SECTION 00 91 01

**ADDENDUM NO. 1**

This document includes requirements that clarify or supersede portions of the Request for Proposal. This Addendum is a Contract Document.

**BUILDINGS 5 & 6 RENOVATIONS**  
 San Mateo County Community College District

**28 EAST WING WALL ELEVATION**

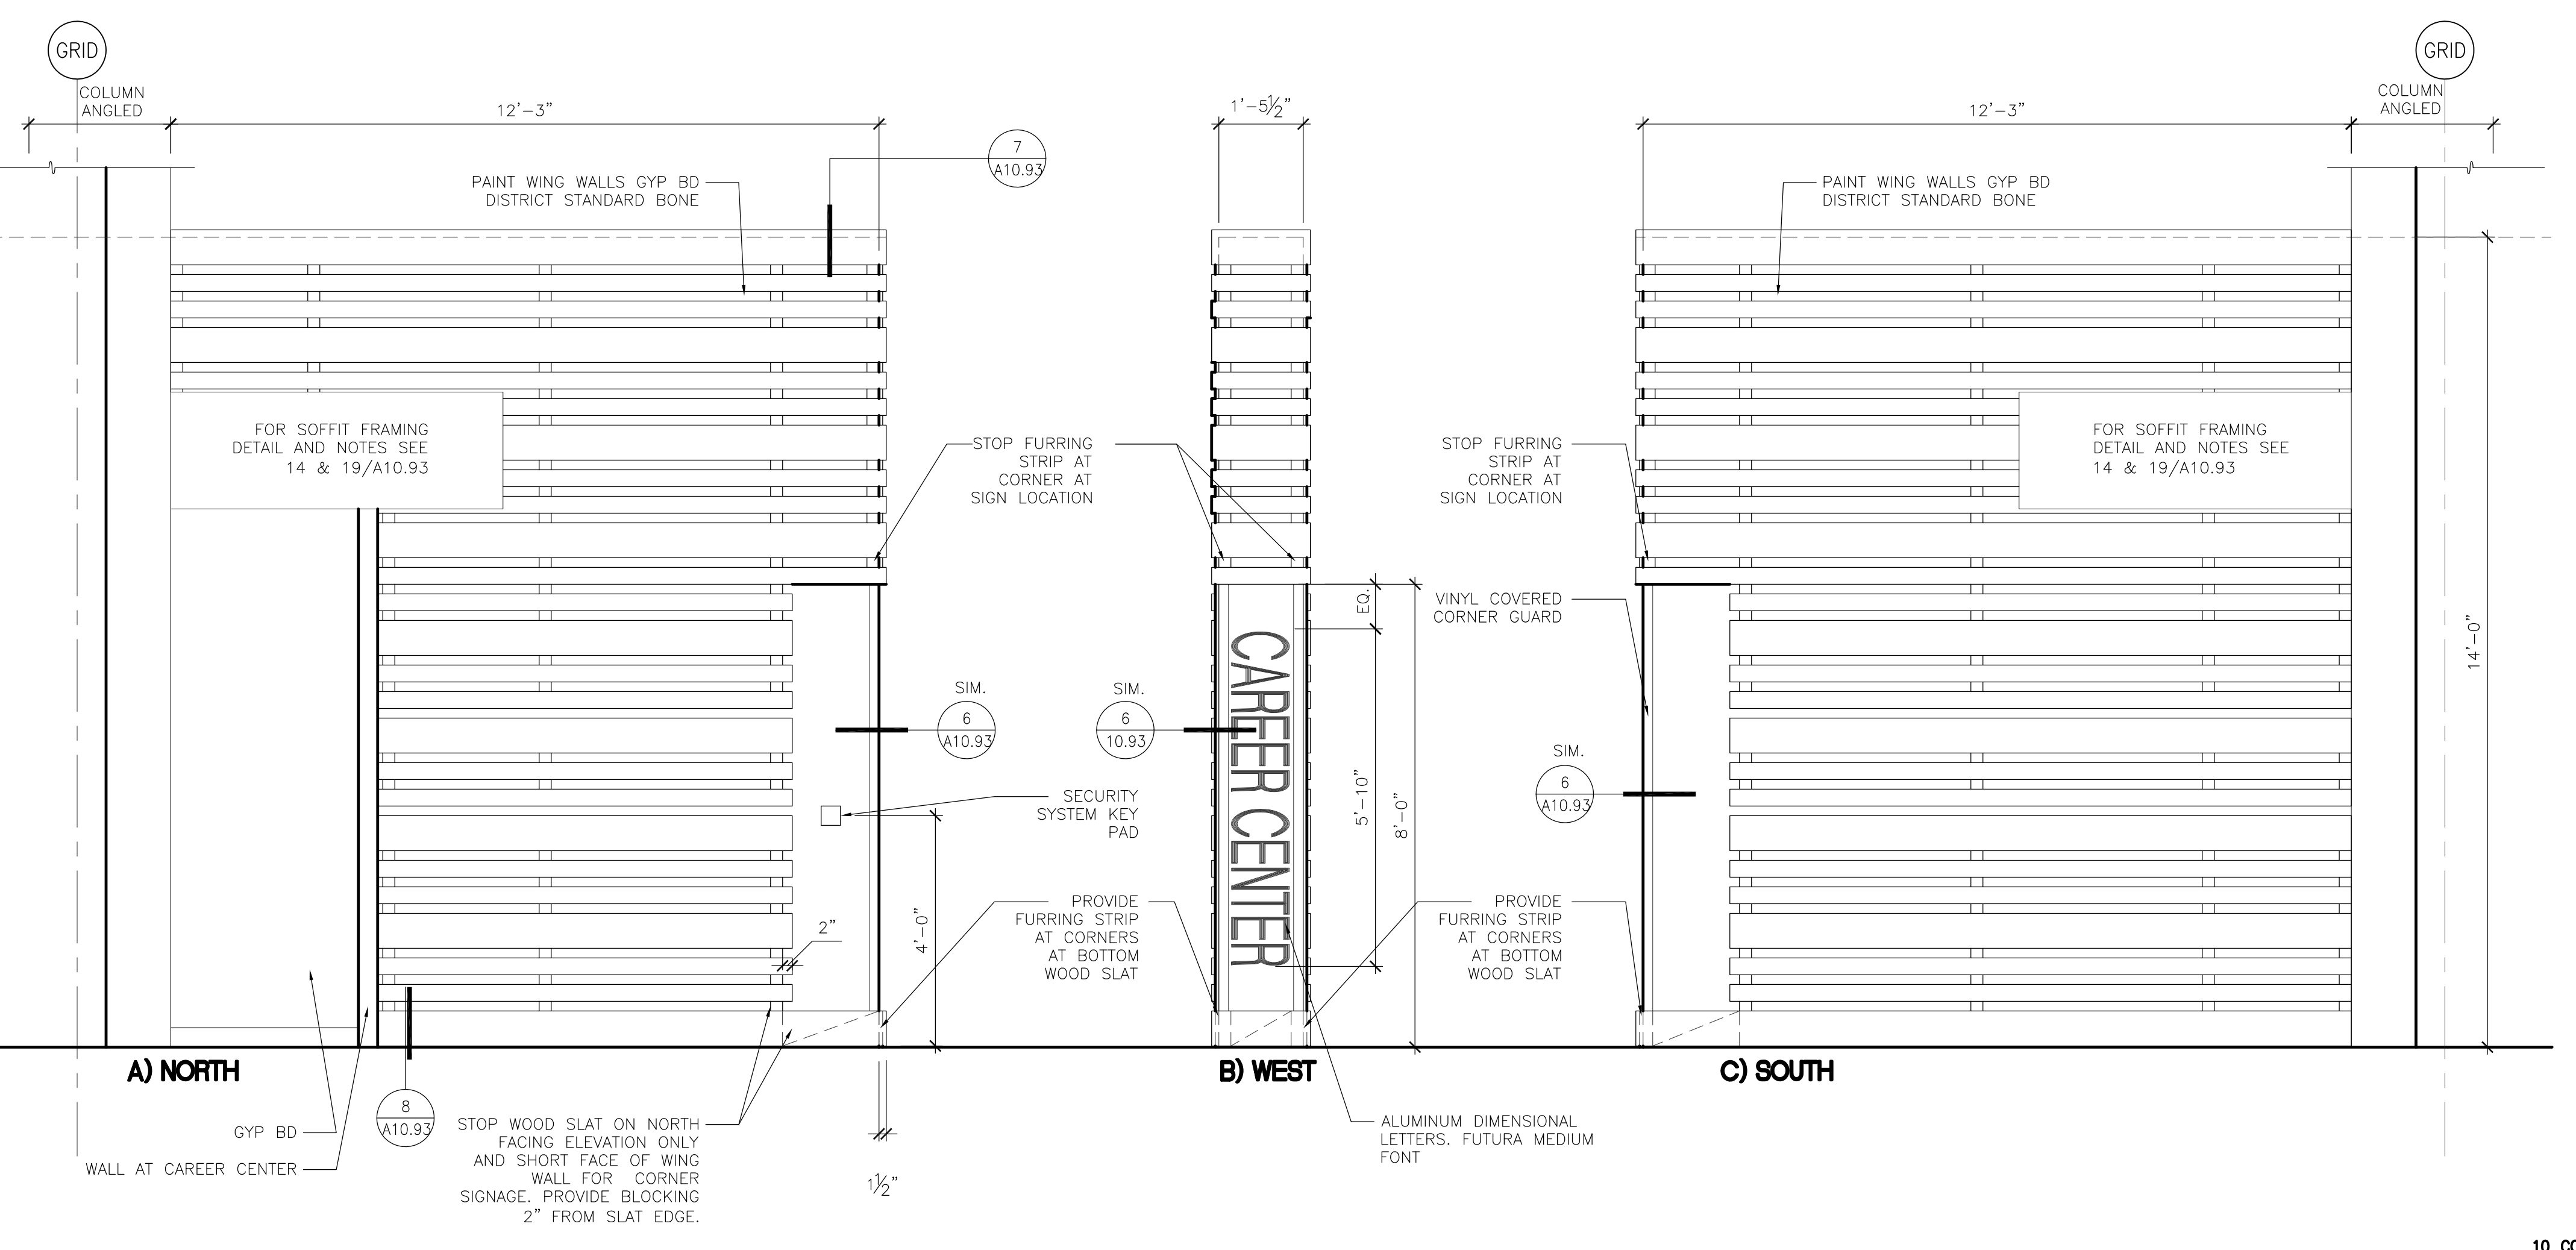
- A. Deleted Detail 28, as shown on attached Drawing A10.93R.
10. Drawing A10.94R – Wall Types and Casework Details
  - A. Revise Detail 30, as shown on attached Drawing A10.94R.

Drawing Number  
**M2.3d**

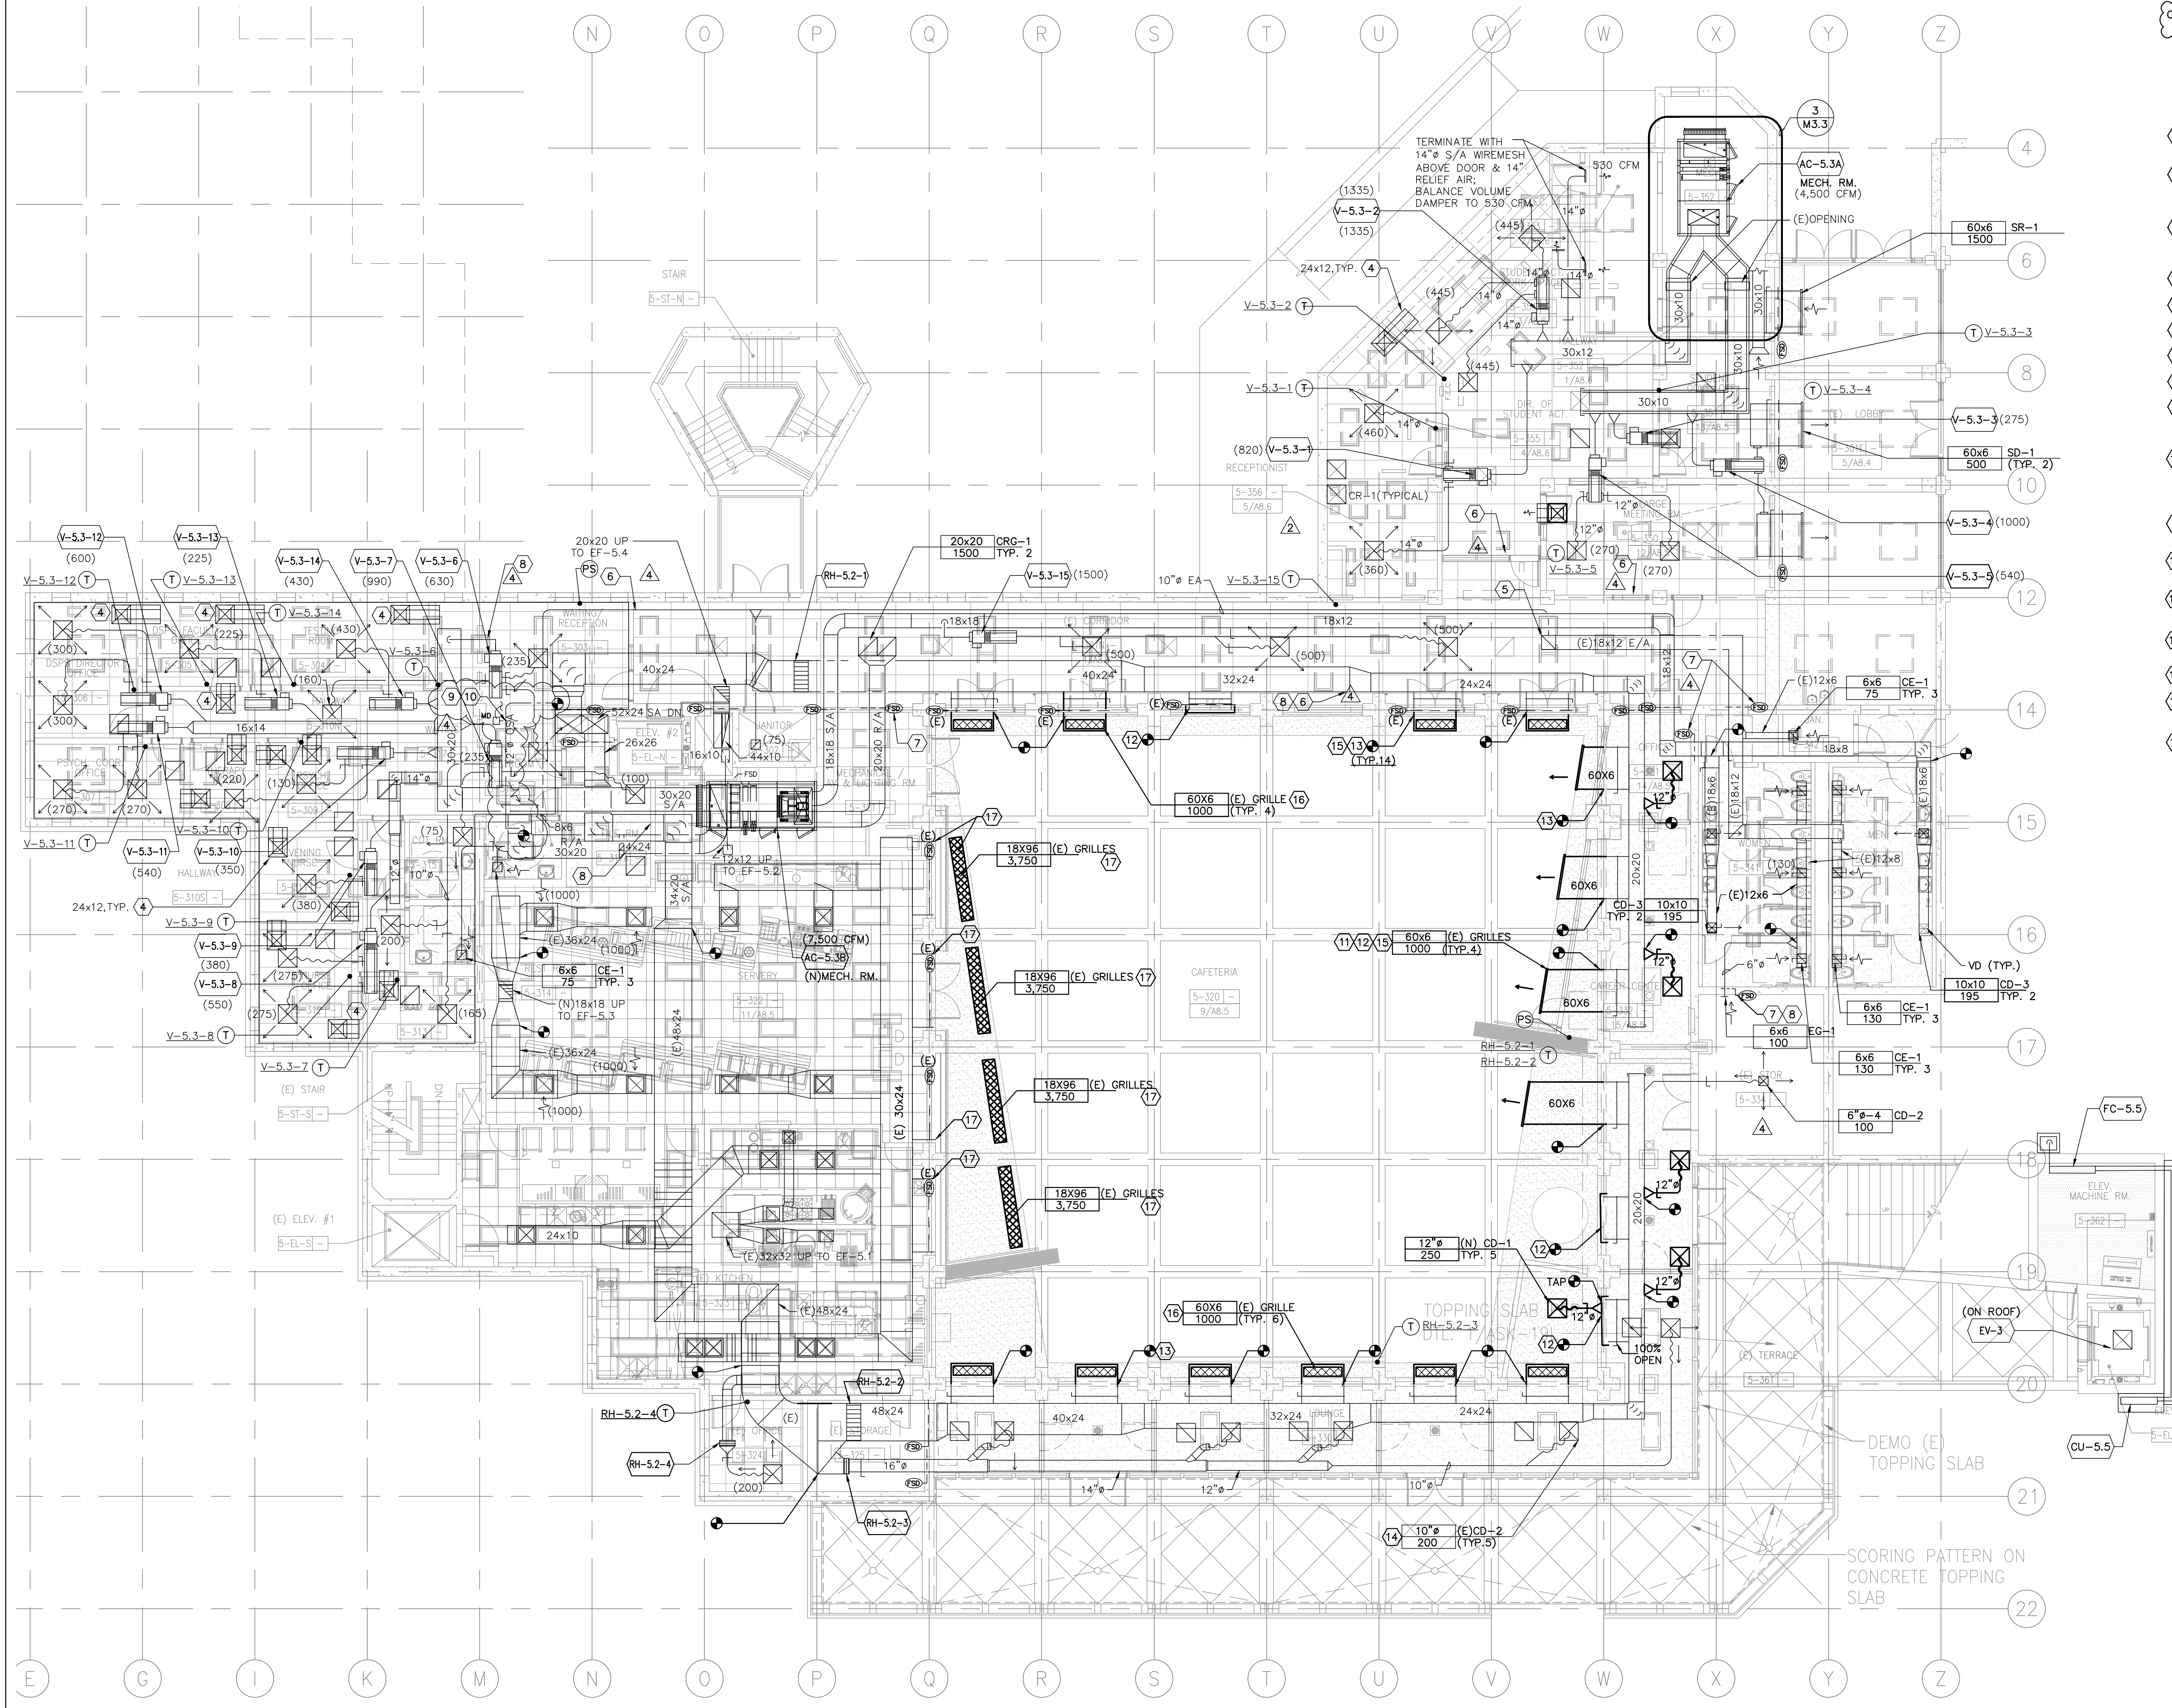
11. Drawing M2.3d – Mechanical Ductwork Plan – Third Floor.
  - A. Added General Sheet Note C, as shown on attached revised Drawing M2.3d.
12. E0.2 – Luminaire Schedule & Title 24 Calculations

1 THIRD FLOOR PLAN - LIGHTING

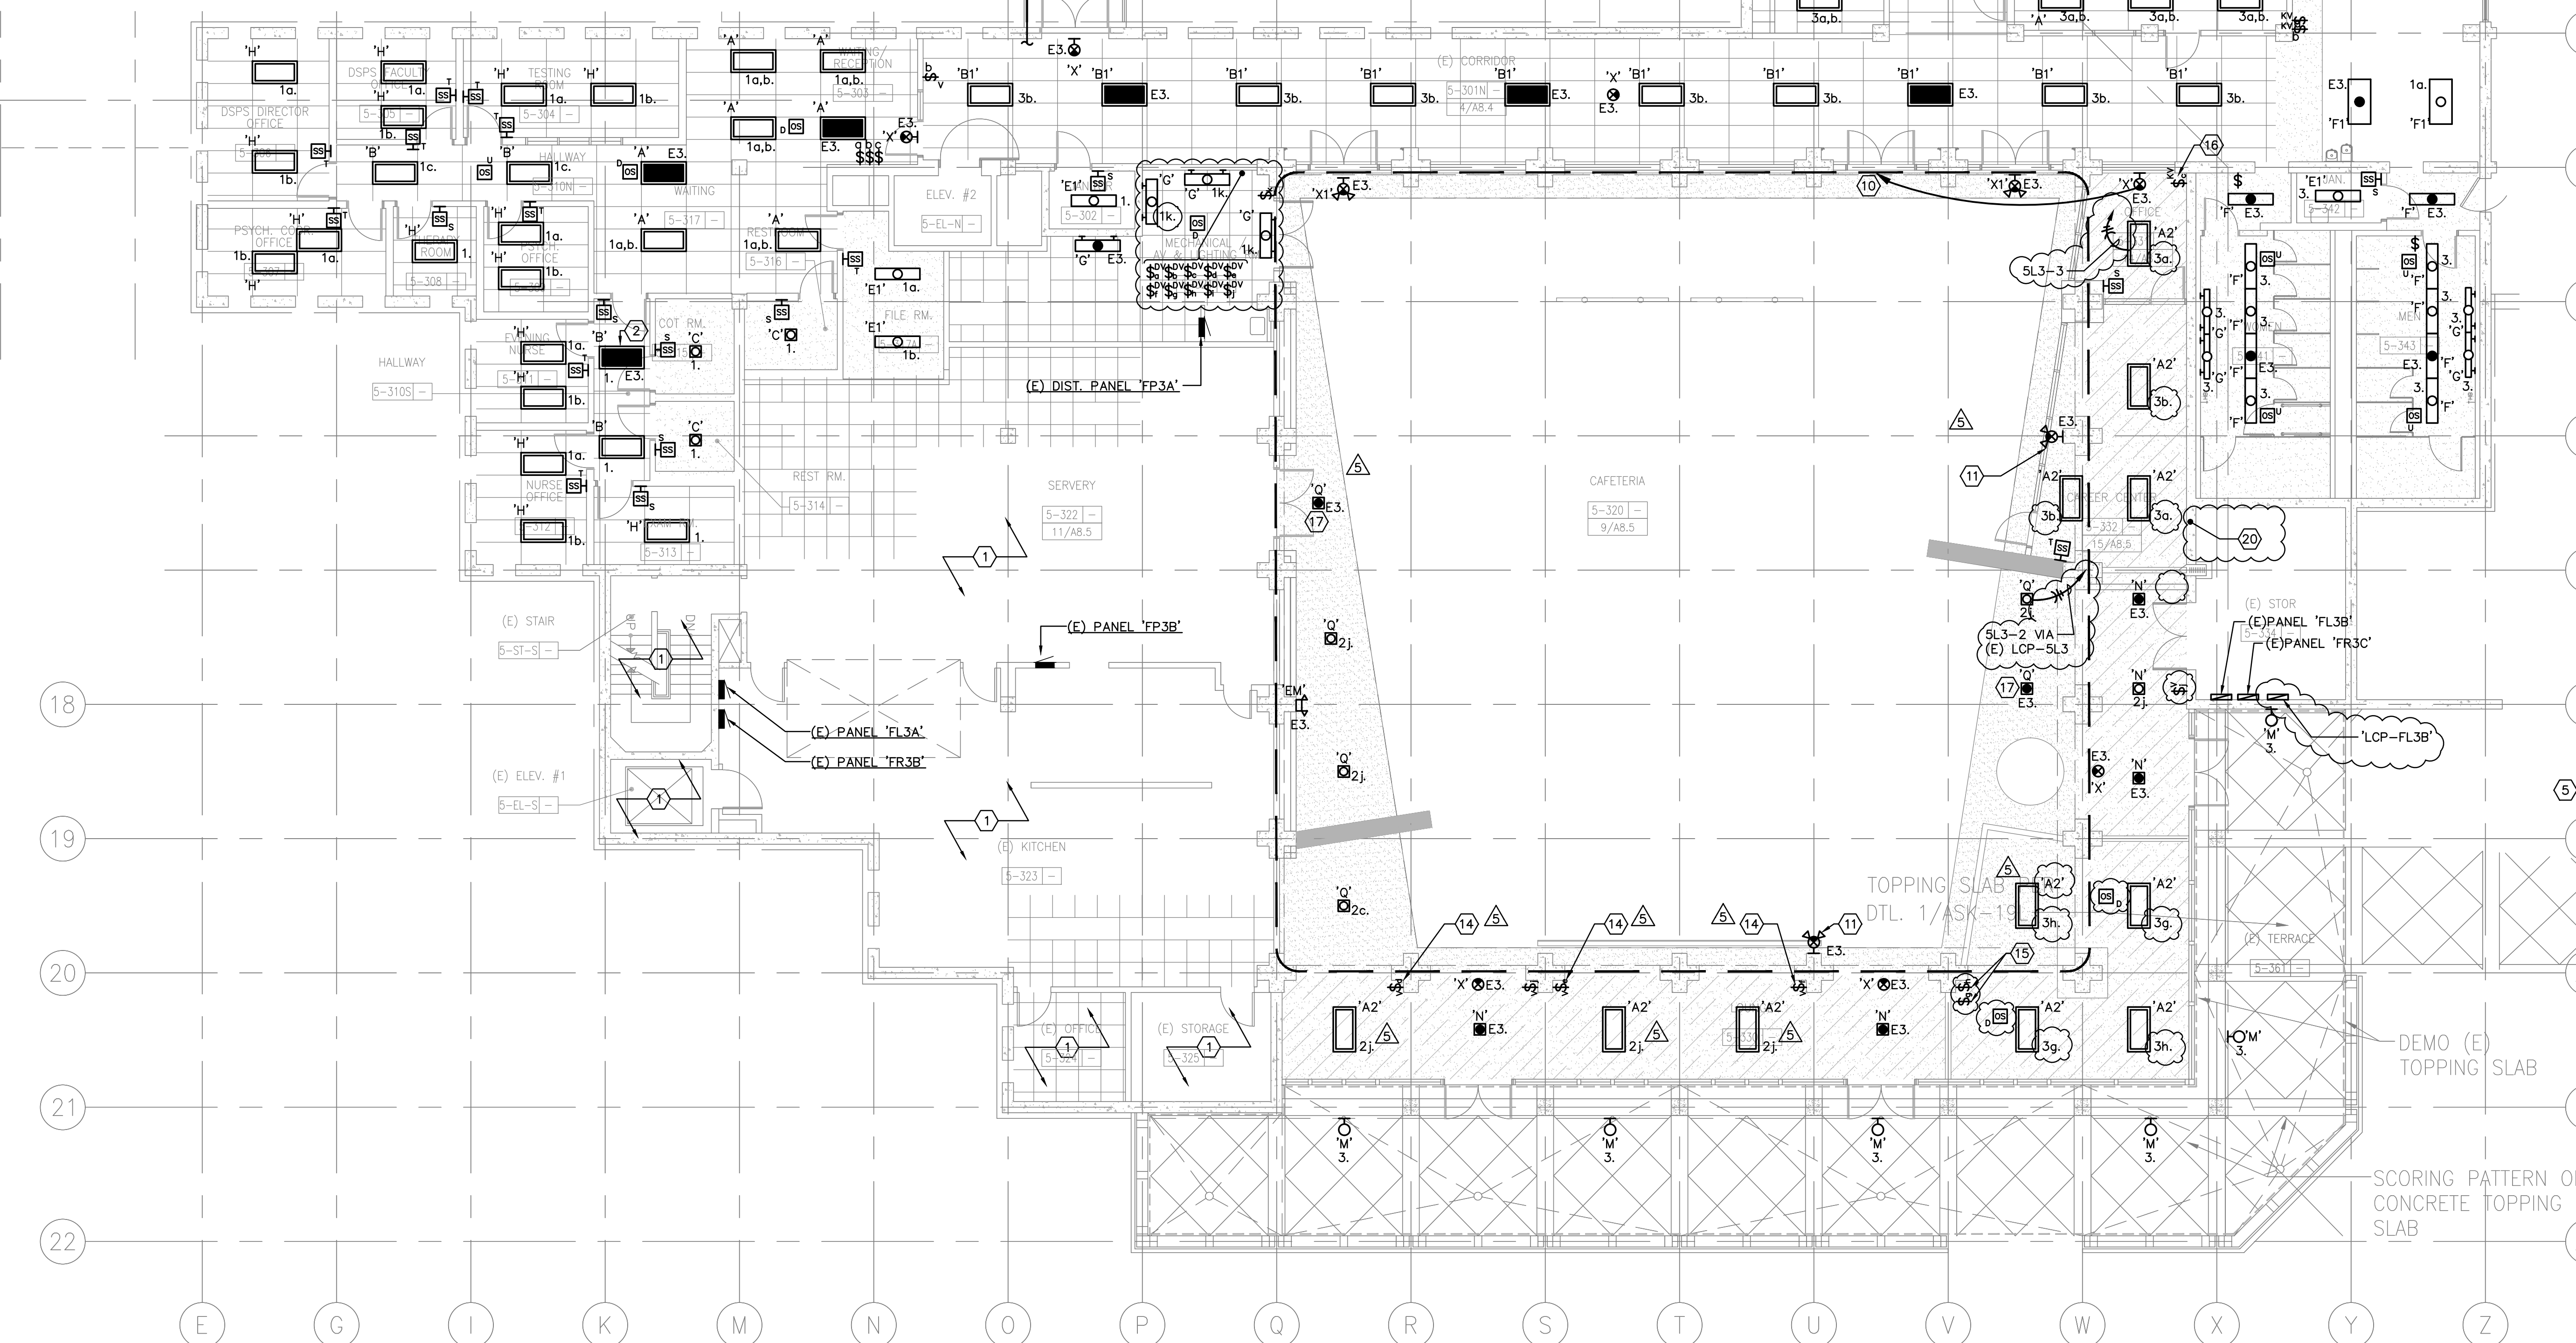
3. Added “Type T1” Light Fixture information as shown in Luminaire Schedule on attached Drawing E0.2.
13. Drawing E2.3 – Third Floor Plan – Lighting.

- A. Modified drawing as shown on attached revised Drawing E2.3:
    1. Revised location of type stage lighting (types T and T1).
    2. Revised circuiting of stage track lighting (type T and T1).

3. Added on type „P” fixture as part of Add Alternate 8.
    4. Revised switching og type „G” fixture in A/V Room.
    5. Revised circuiting and switching in Student Lounge.

6. Showed location of „LCP-FL3B”.
    7. Relocated switch „j”.
    8. Added General Sheet Note D.
    9. Added Lighting Control Panel in (E) Storage RM 5-334.

10. Revised Sheet Notes 12,13 and 15.

11. Added Sheet Notes 19 and 20.
  12. Relocated lighting control switches to North Wall of Mechanical / AV & Lighting Rm 5-321.
  13. Revised dimensions at Detail 3: Type P Mounting Detail.

14. Revise circuiting in Career Center
14. Drawing E3.3 – Third Floor Plan – Power
- A. Modified drawing E3.3 as shown on attached revised Drawing E3.3:
